REMARKS/ARGUMENTS

Application Serial No. 10/673,014
Reply to Office Action of October 4, 2004

Amendments To The Drawings:

FIG.5A

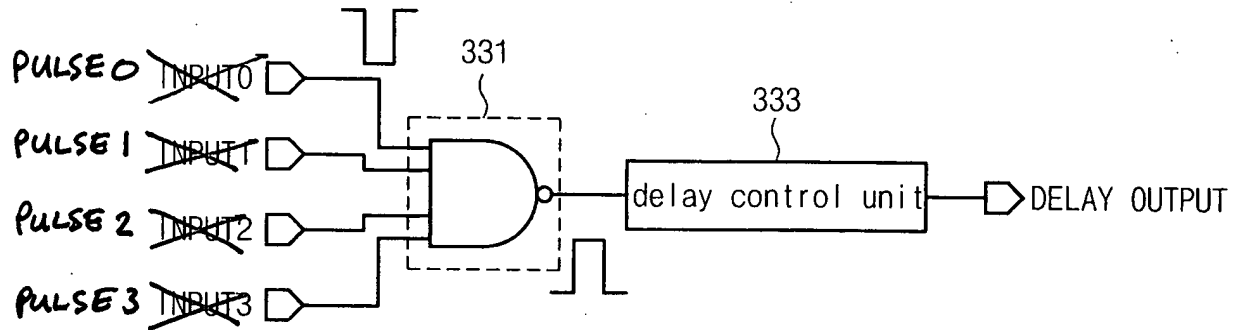
The Specification page 9, lines 2-8 and 12-19, and FIGS. 5A and 5B have been amended to remove inadvertent and minor typographical errors. No new matter has been added.

The attached sheets of drawings include changes to FIGS. 5A and 5B. These sheets contain corrections shown in red for the Examiner's approval and are requested to replace the original sheets of FIGS. 5A and 5B.
